**KENYA LITERATURE BUREAU**  
**TENDER FOR INSTALLATION OF LOCAL AREA NETWORK INFRASTRUCTURE**  
**TENDER NO: KLB/RT/21/2021-22**

**ADDENDUM**

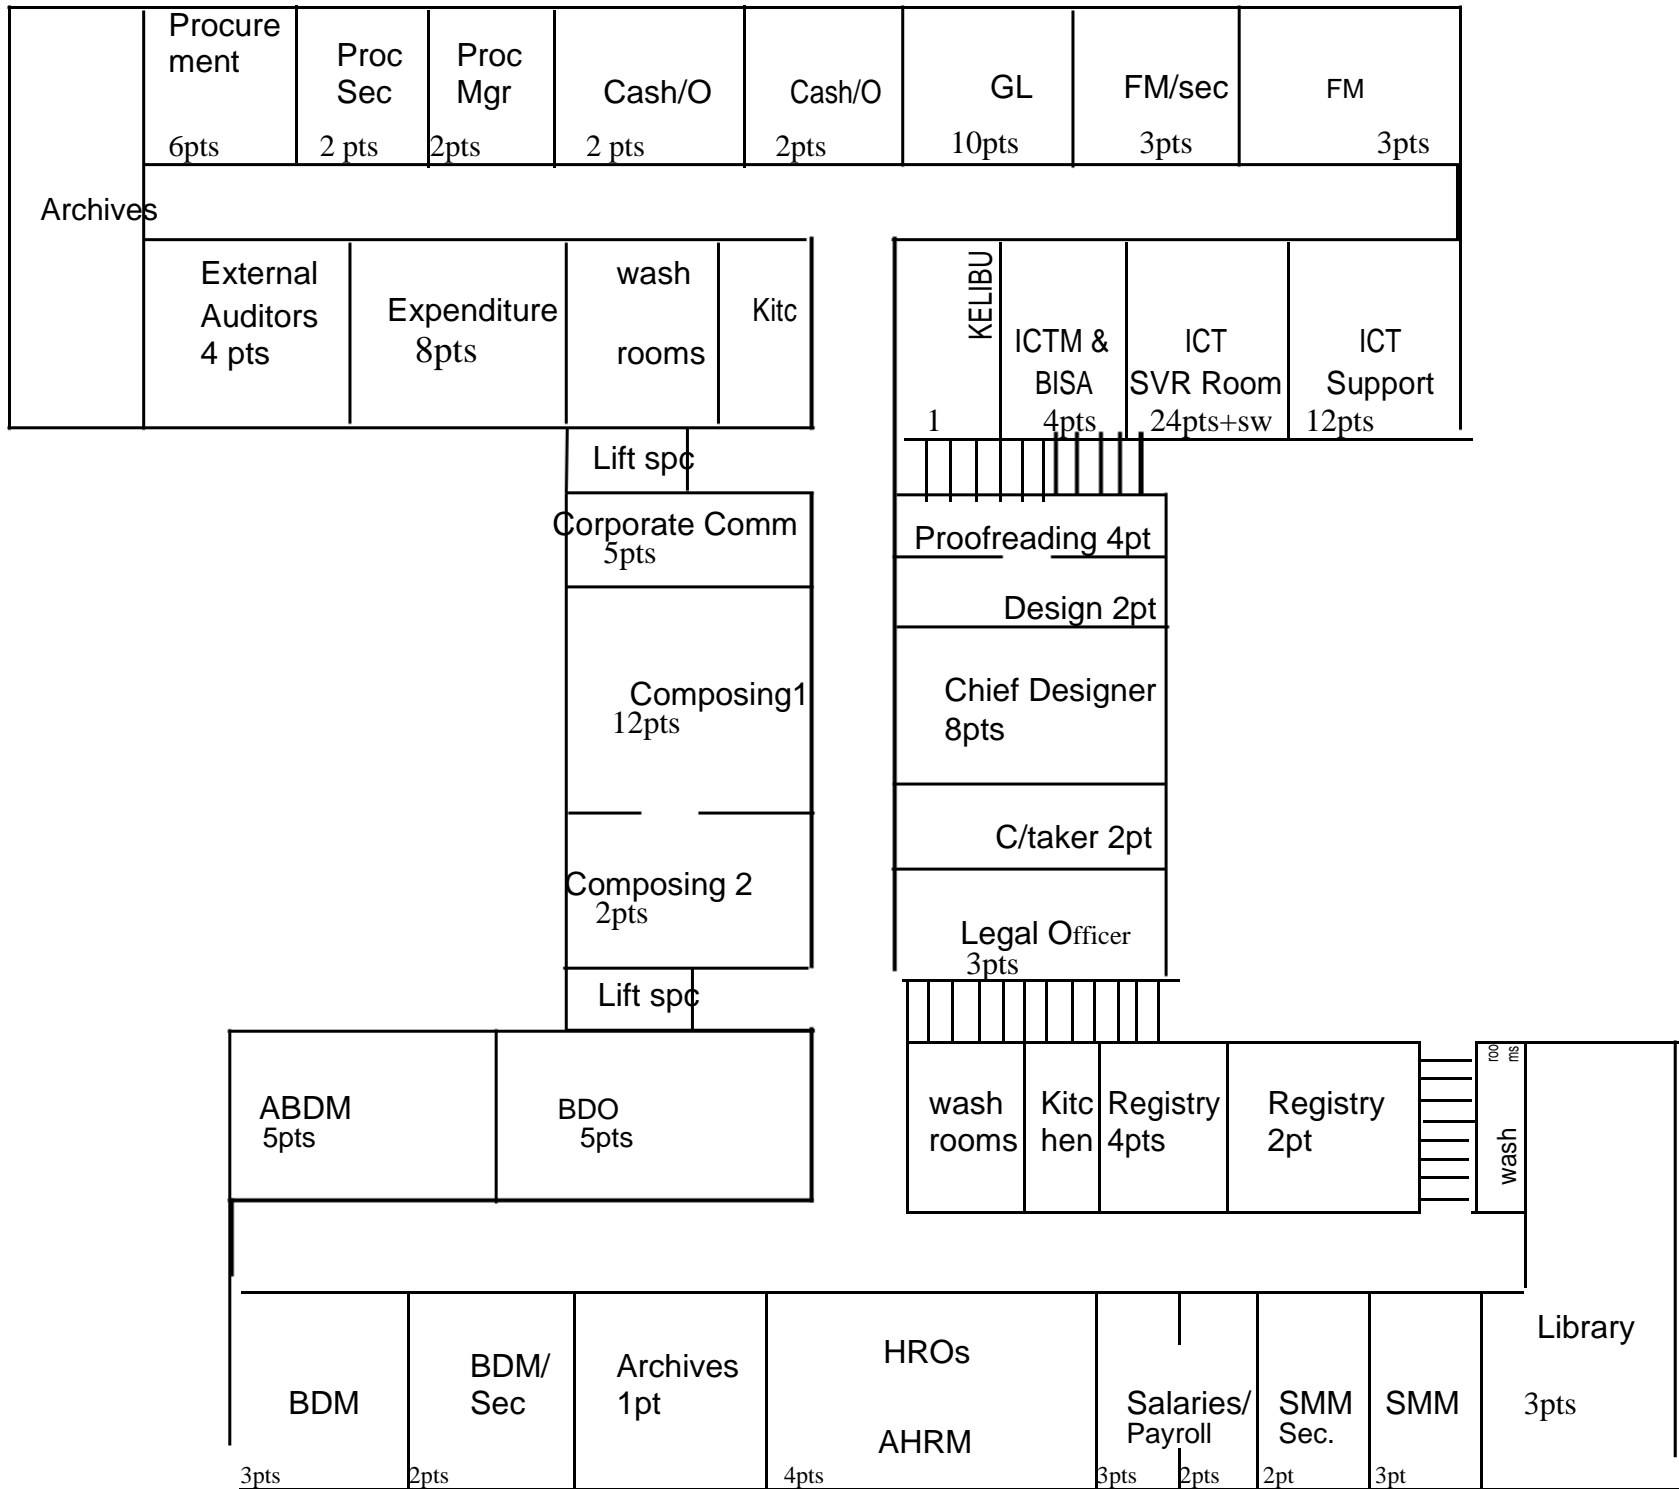
1. Five (5) revised floor plans and dimensions are provided. The floor plans as indicated below.
  - a. Ground floor, Production, warehouse, stores
  - b. 1<sup>st</sup> Floor production
  - c. Ground Floor, main building
  - d. 1<sup>st</sup> Floor, main building
  - e. 2<sup>nd</sup> Floor, main building
2. The LAN must support Network monitoring, VLAN setup and enhanced Security features.
3. External dimensions of the building are given in the floor plans. The individual office dimensions shall be estimated by the bidder. The plans are not drawn to scale.
4. The distribution of the network points is as indicated in the plans.
5. Wireless access points locations are indicated in the plans: Wi-Fi Floor Plan
